IREDELL COUNTY HEALTH DEPARTMENT

IMPROVEMENT PERMIT / AUTHORIZATION TO CONSTRUCT / OPERATION PERMIT / EXISTING SYSTEM INSPECTION

PERMIT# 152859 PIN# 4710297890 DATE 11-6-08

SUBDIVISION Harbor Watch BLOCK / SECTION I LOT 20 LOT AREA 1.12 SITE CLASS. 12 DESIGN FLOW 480 L.T.A.R. .3

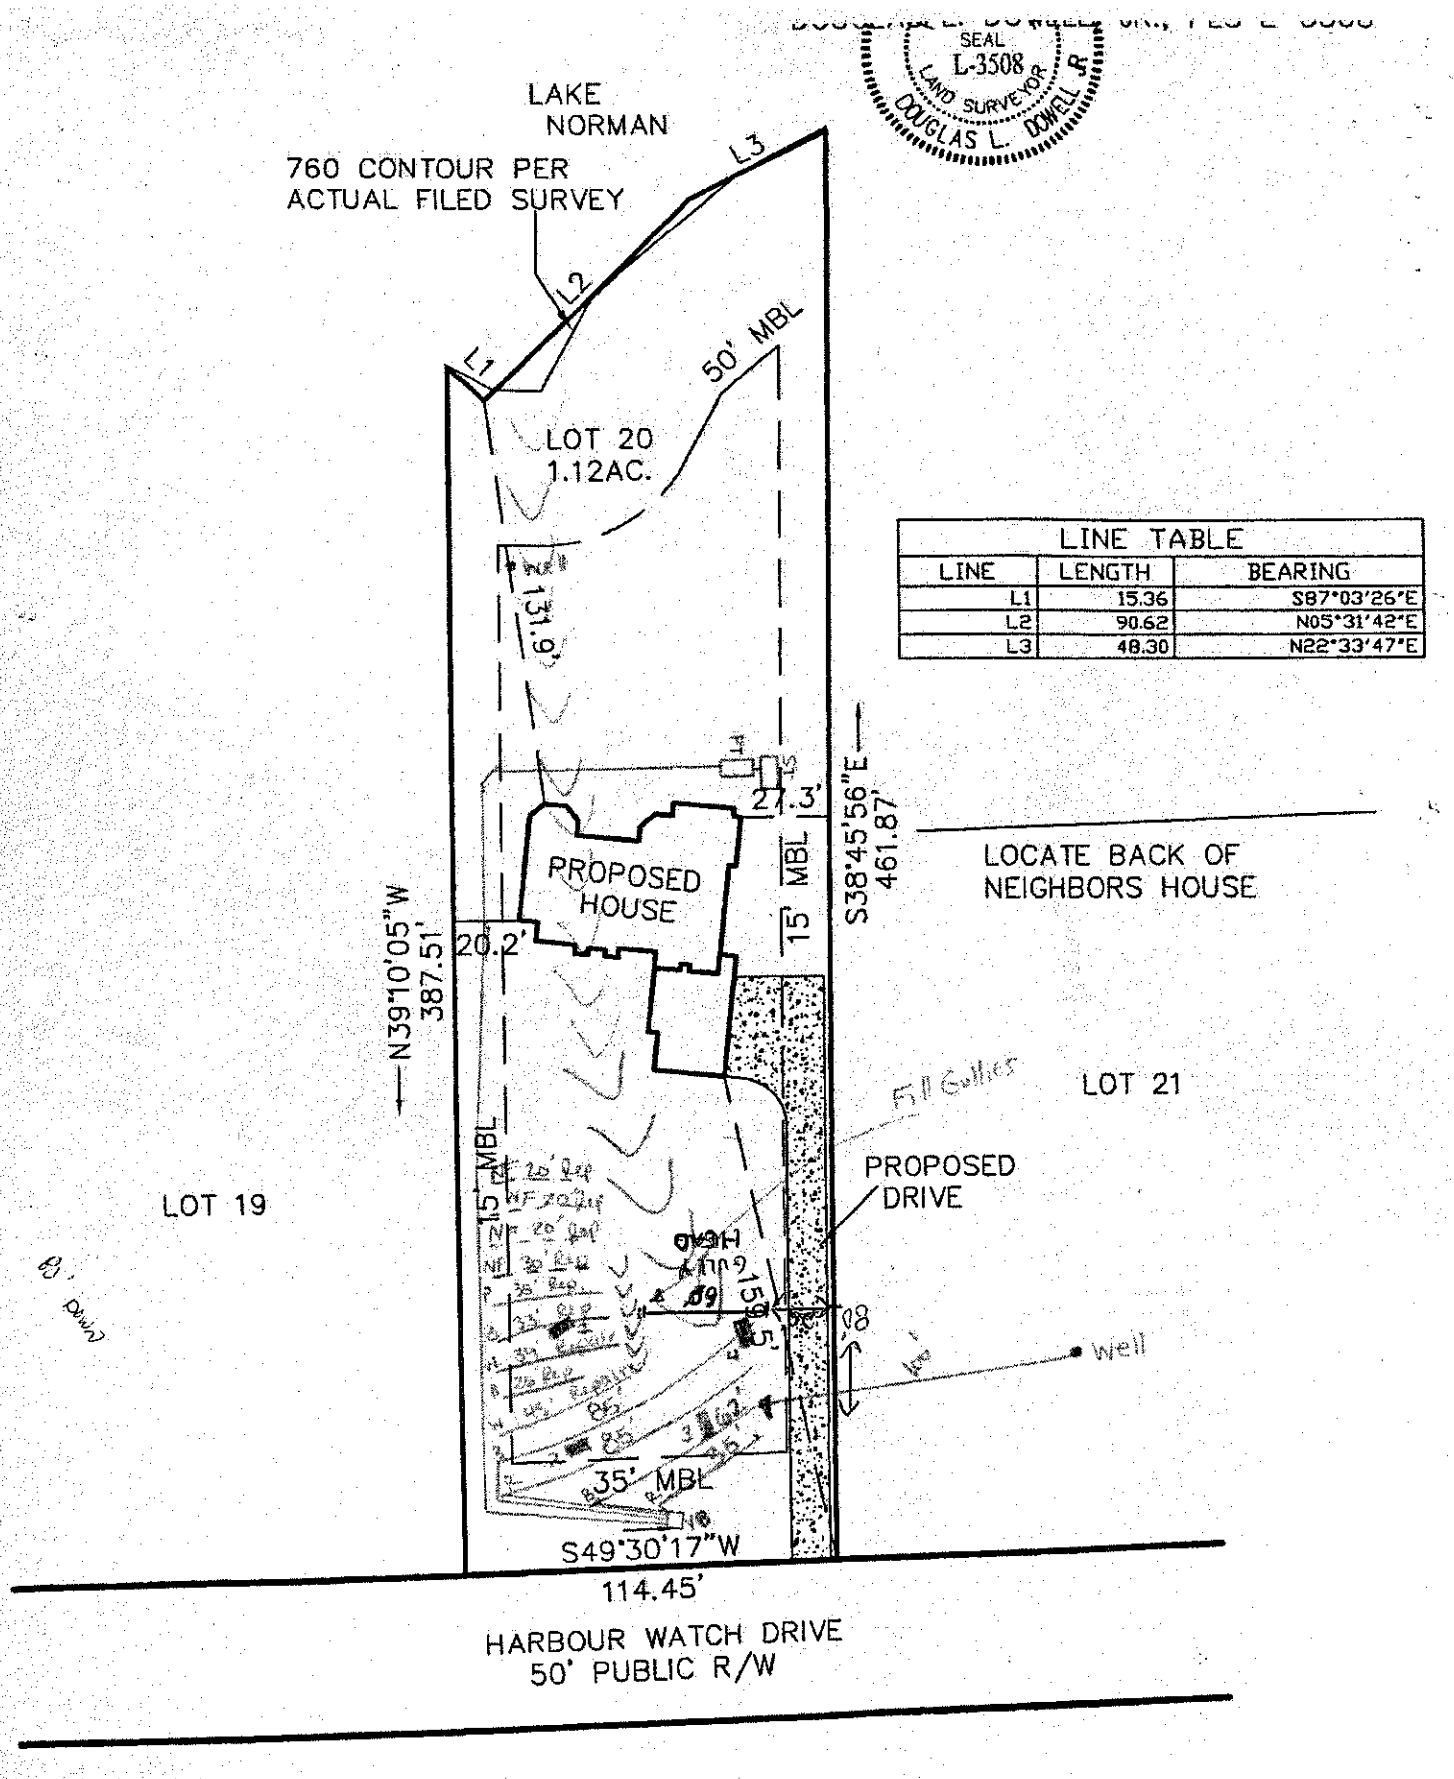
Comments/Conditions: (1) System AND Home FLAGGED OUT Completely (2) Gullies will have to be filled & bushes will have to be graded out to the lowest contour point uniformly. A PRE Construction

Comments/Conditions: VISIT MUST BE MADE B4 Grading and filling takes place. (3) IF ONLY UNTIL Site conditions are properly excavated and filled. IF conditions of grading is not properly excavated permit could be void.

(4) SAME must be required to make visit to investigate grading & filling.

(5) AFTER Site Conditions Are MADE Suitable System Area Must BE FENCED OFF SO SYSTEM AREA IS NOT DESTROYED

(6) WELLS MUST BE 100' FROM System DUE TO SACCOLATE

(7) MUST USE Filter-Lateral PUMP TANK

(8) KEEP HOUSE OUT OF GROUND & BACKFILL FOR POSITIVE DRAINAGE REQMTS.

(9) MAINTAIN SETBACKS
